N6735B-01

S E R V I C E N O T E

N6735B 50W DC Power Module

Location of C36 and C37

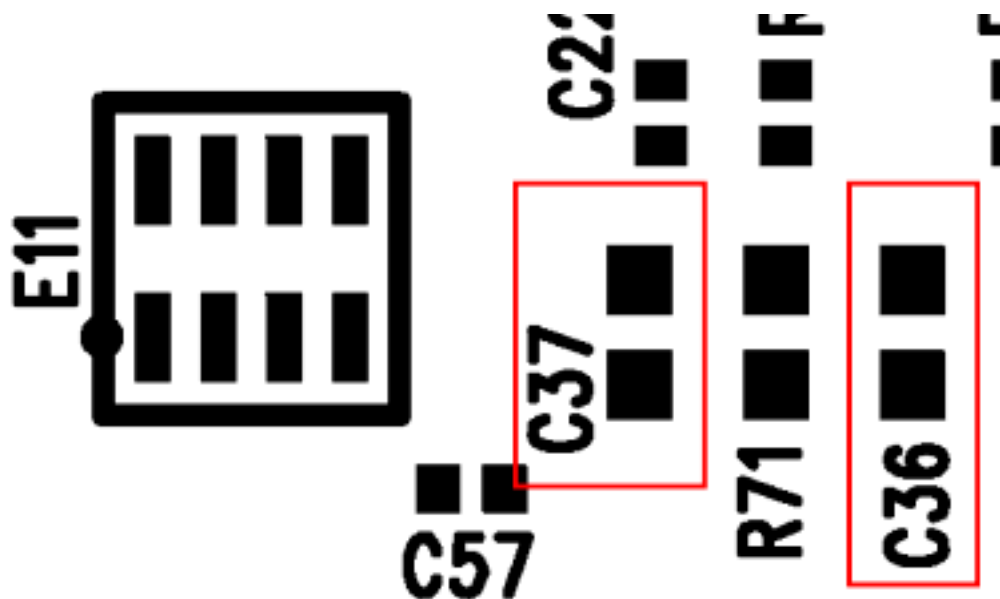
Due to some noise filtering issues, the current measurement accuracy will be out of specification by a fixed offset when there is a voltage being sourced at the output terminals. If the output is shorted, the current measurement accuracy will be within specifications. Please note that the performance verification test will not catch this.

If this measurement is out of specification, replace capacitors C36 and C37 on the DPM assembly (this is the assembly that is vertically mounted in the unit that looks similar to a PC memory module) with part number 0160-7809. After the capacitors are changed, the unit will require re-calibration. After the capacitors are replaced, check the make sure that the unit is in specification by applying 75% of the full voltage range while attached to a load drawing 50 mA to 70 mA. If the current measurement is within the specification, then the unit has been repaired.
